**PSE&G** Public Service  
Electric and Gas  
Company

August 20, 1984

HOPE CREEK GENERATING STATION  
DOCKET NO. 50-354  
DRAFT SAFETY EVALUATION REPORT  
OPEN ITEM STATUS

Attachment 1 is a current list which provides a status of the open items identified in Section 1.7 of the Draft Safety Evaluation Report (SER). Items identified as "complete" are those for which PSE&G has provided responses and no confirmation of status has been received from the staff. We will consider these items closed unless notified otherwise. In order to permit timely resolution of items identified as "complete" which may not be resolved to the staff's satisfaction, please provide a specific description of the issue which remains to be resolved.

FIGURE A-13-2  
 RESPONSE SPECTRA COMPARISON,  
 UNIT 1 REACTOR BUILDING AT ELEV. 54' - 0",  
 N-S, SSE, 2% DAMPING

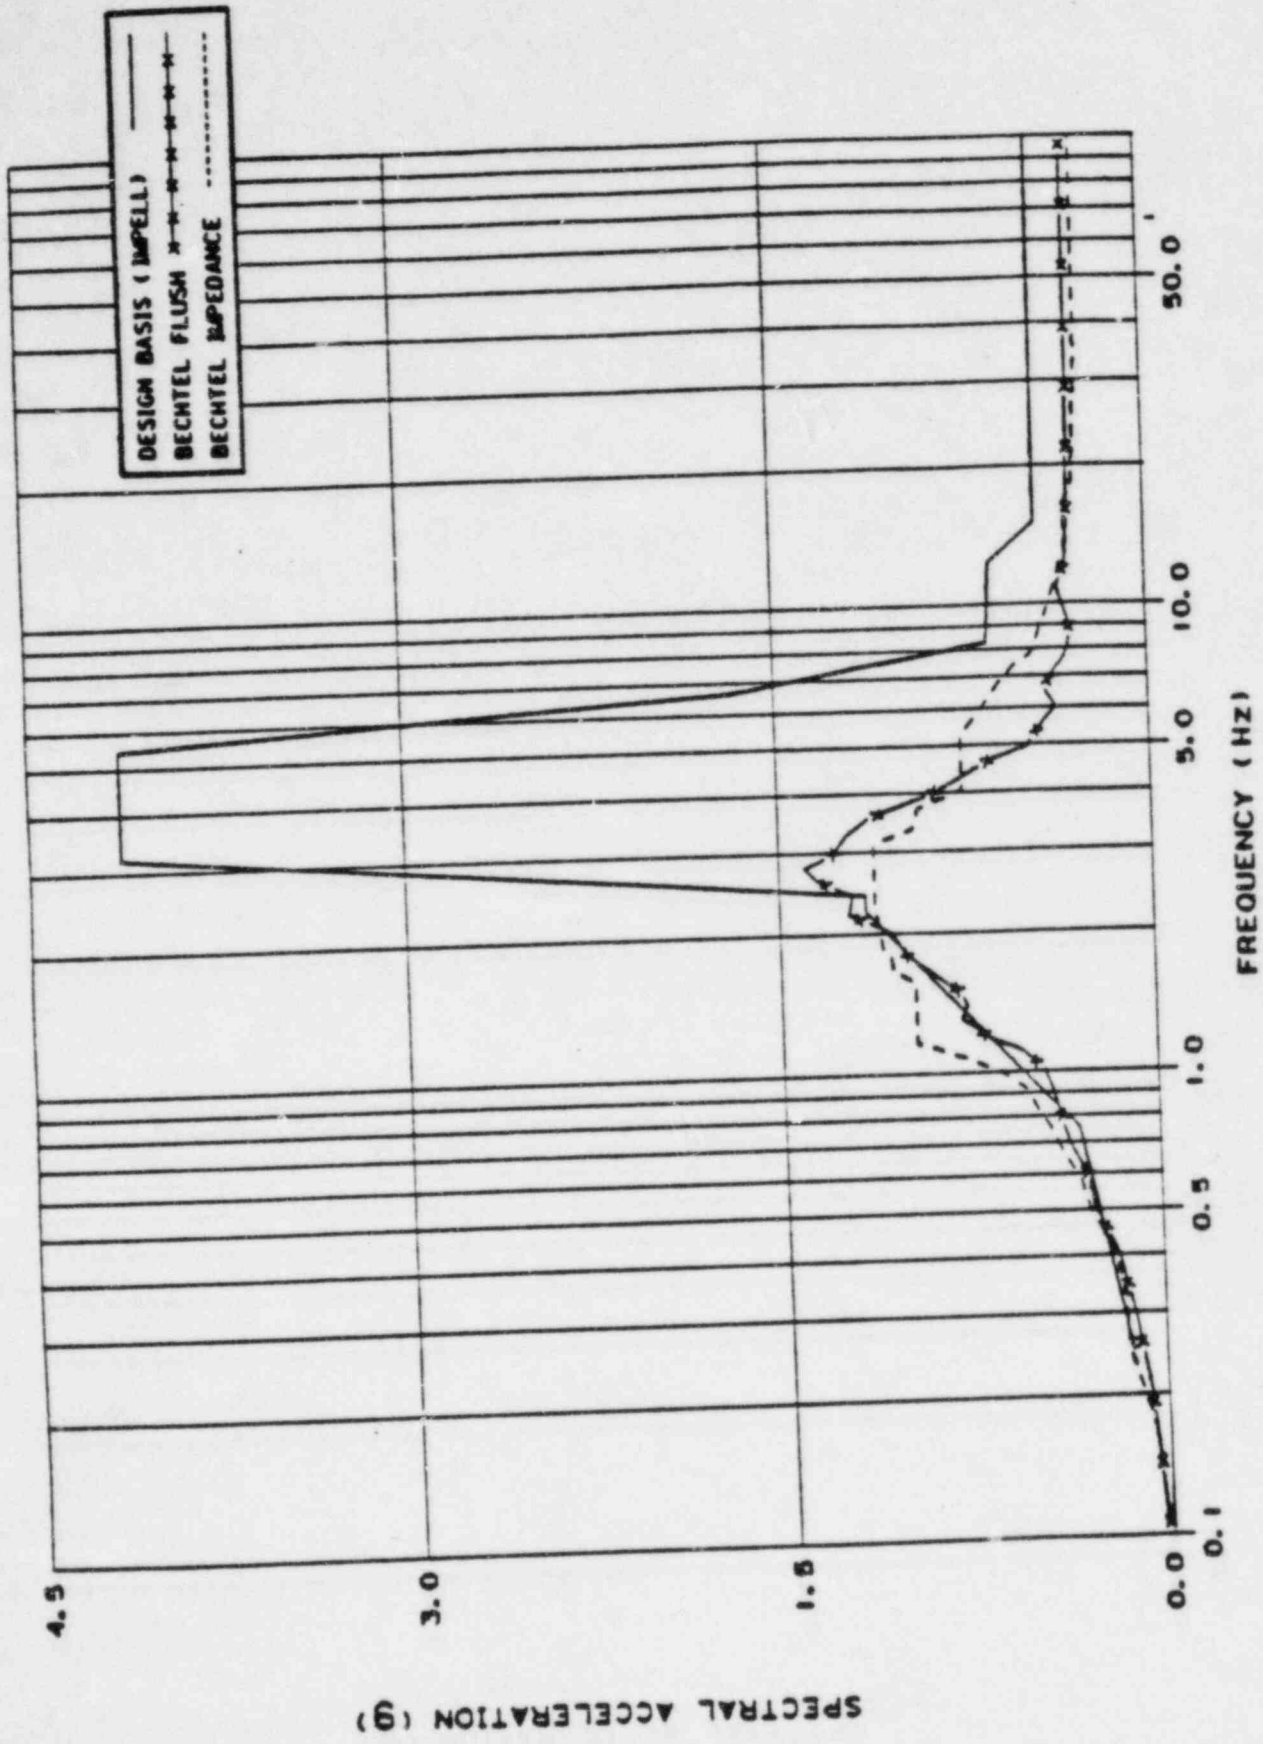
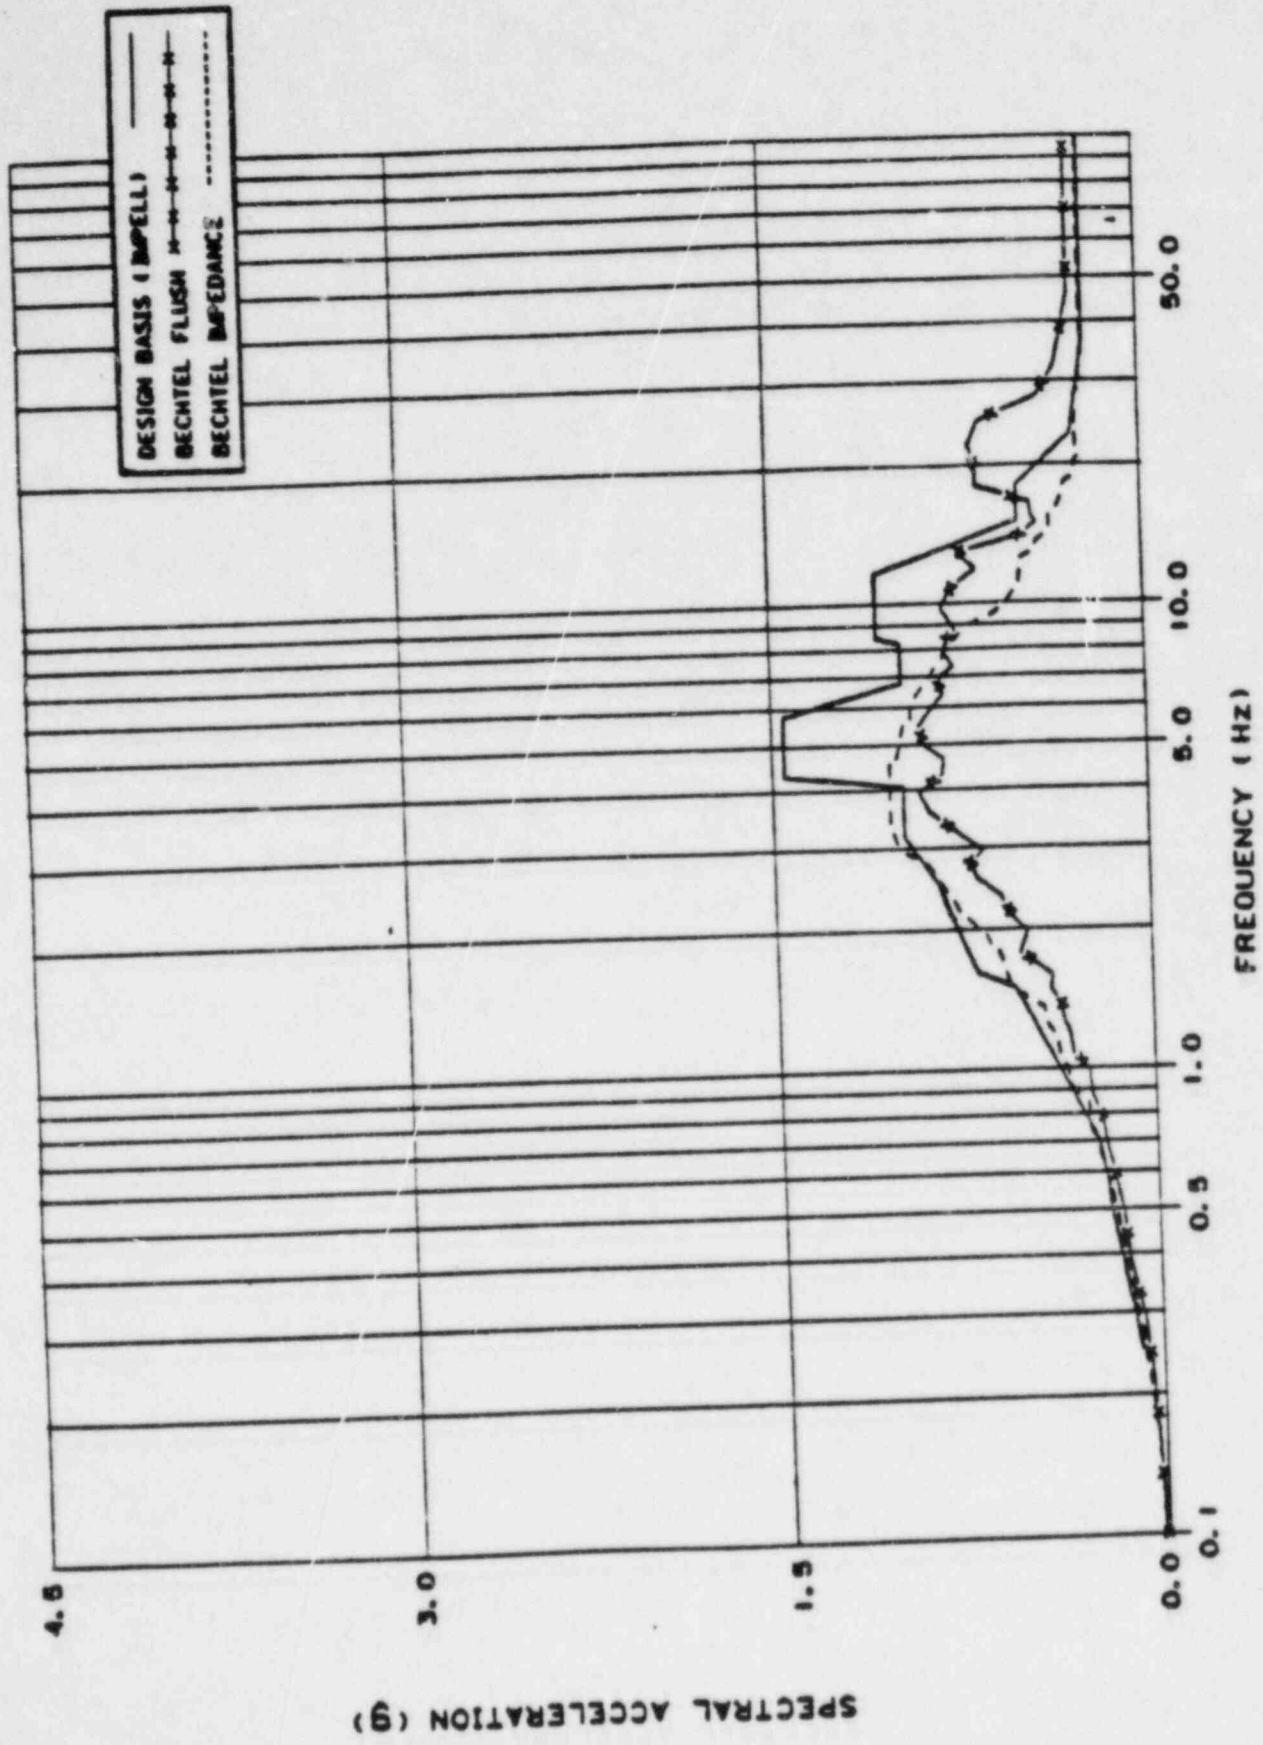
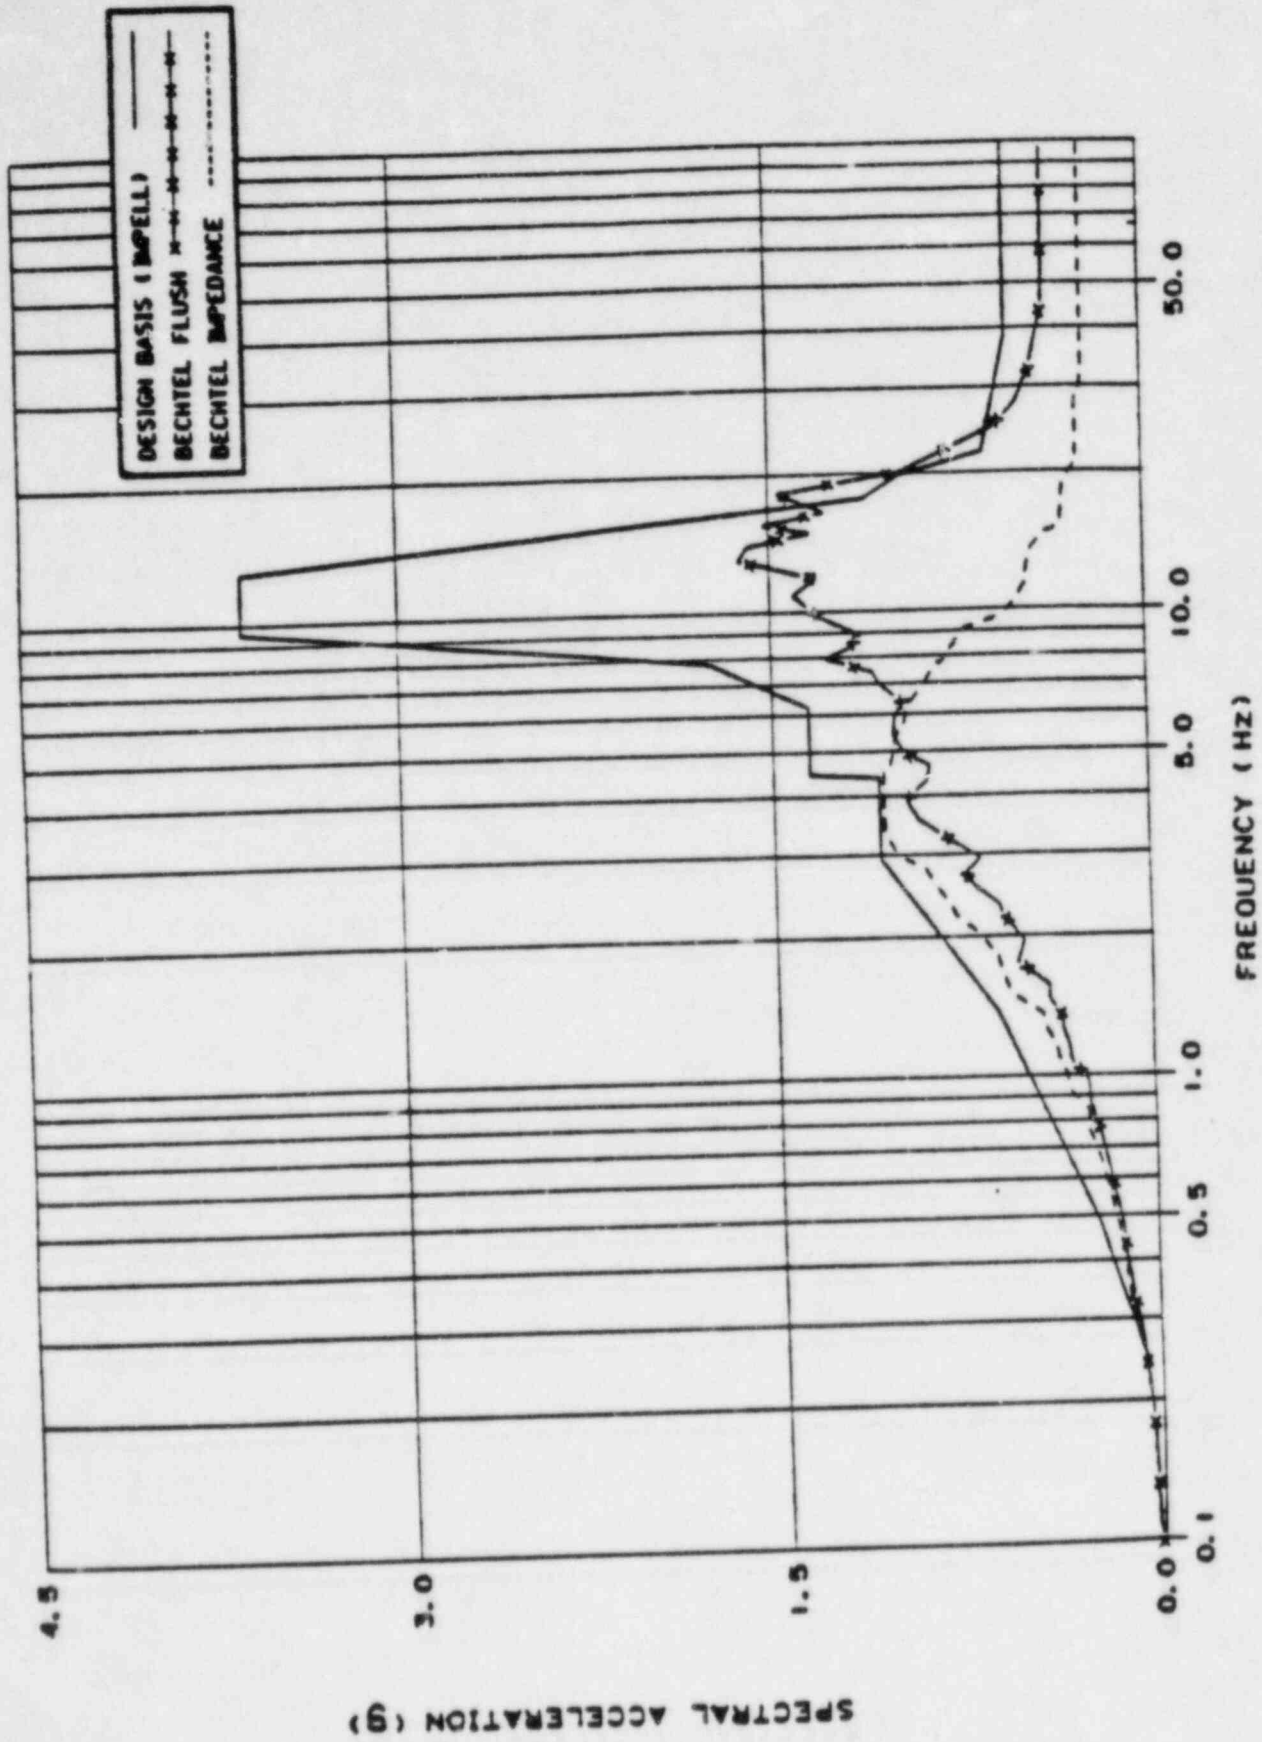
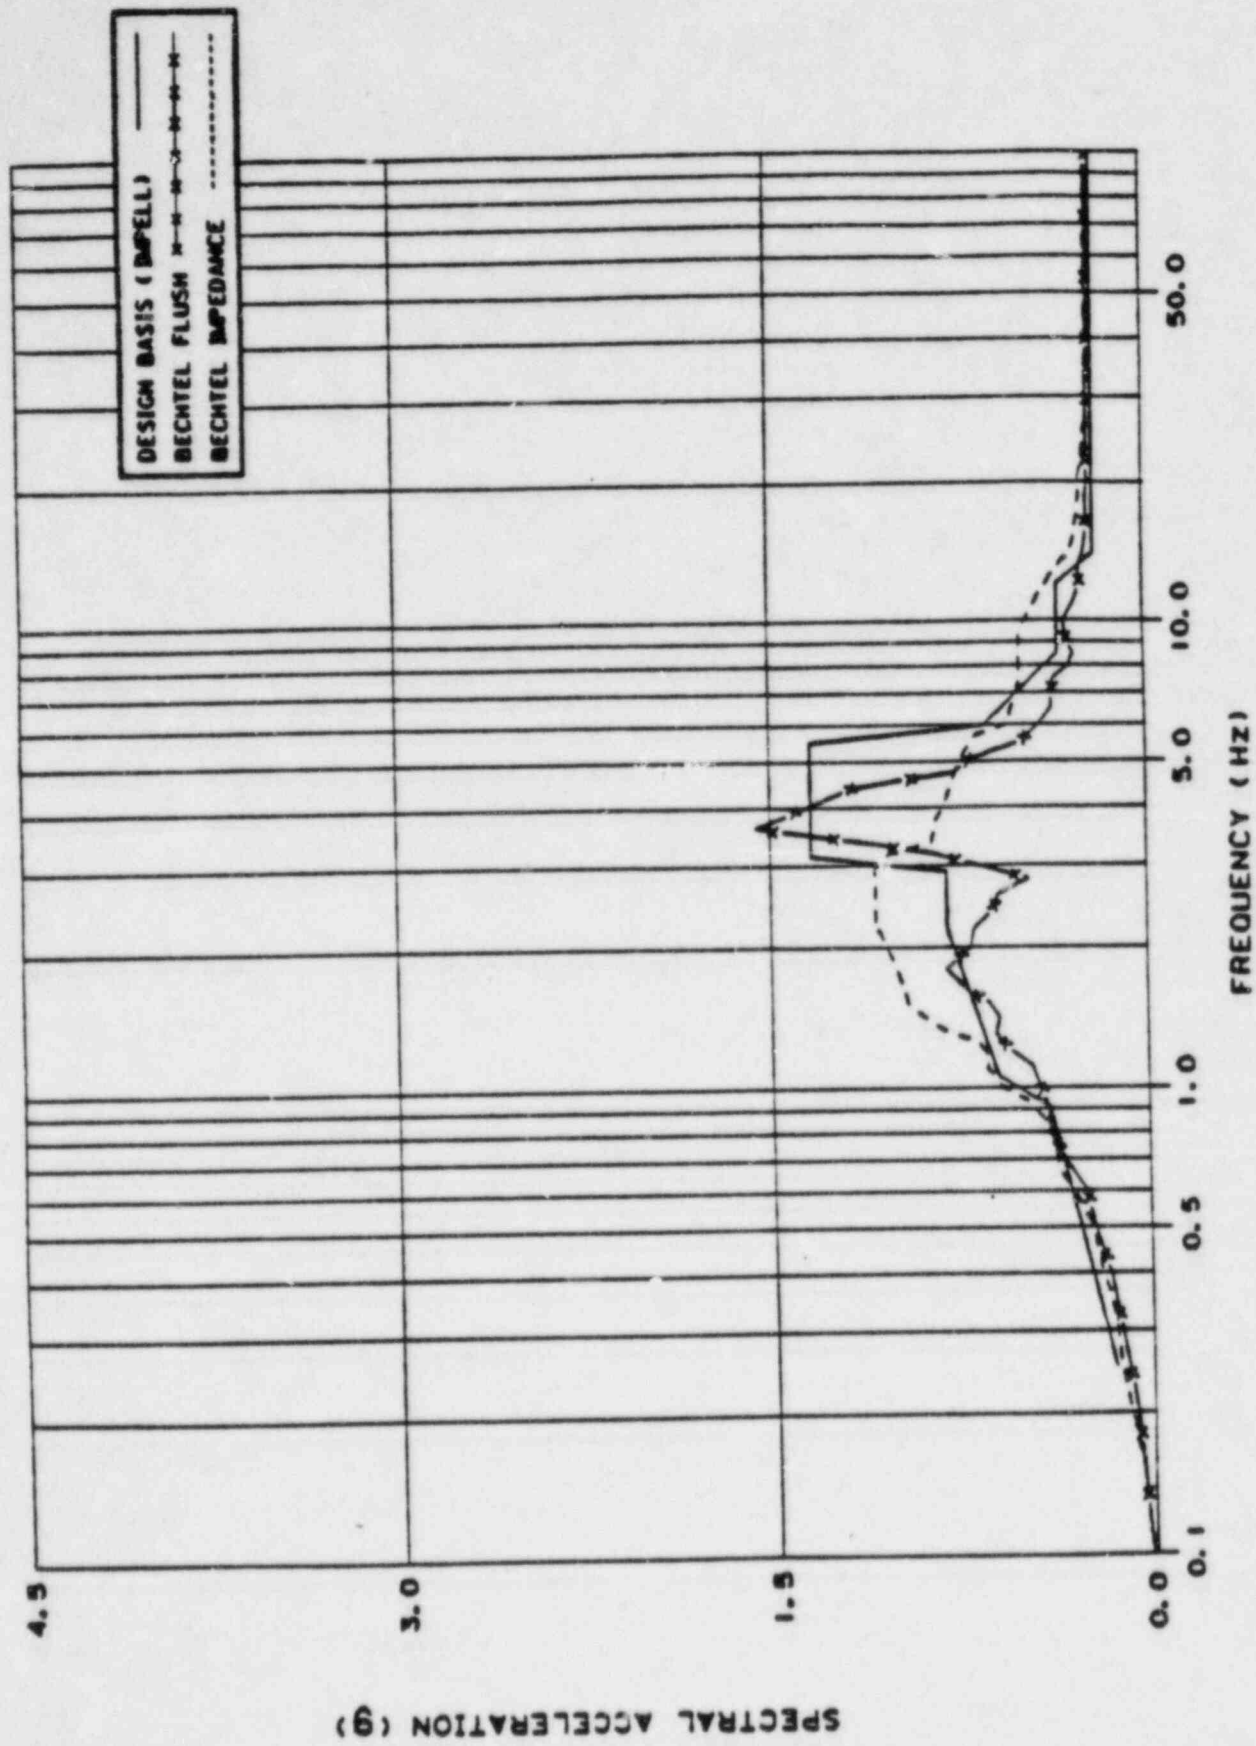
Figures A-13-2 to A-13-37 show the comparison of the response spectra (2% damping) obtained from the above three seismic soil-structure interaction analyses. Discussions of these comparisons are as follows:

Bechtel's independent soil-structure interaction analyses are performed using the computer code FLUSH. The results of independent finite element analyses are in reasonable agreement with those of the design basis analyses. As can be seen from Figures A-13-2 through A-13-37, the horizontal response spectra obtained from the independent finite element analyses are generally enveloped by those obtained from the design basis analyses except for the frequency range lower than 2 Hz. The vertical response spectra showed some exceedances at the frequency range of 18 Hz. These exceedances are listed in Table A-13-1.

The peak spectral accelerations obtained from the impedance approach analyses are generally lower than those obtained from the design basis analyses. However, these response spectra are not completely enveloped by those obtained from the design basis analysis, especially in the frequency range between 1.0 and 3.5 Hz. Also, there are some local exceedances in the higher frequency range, as shown in Figures A-13-2 through A-13-37.
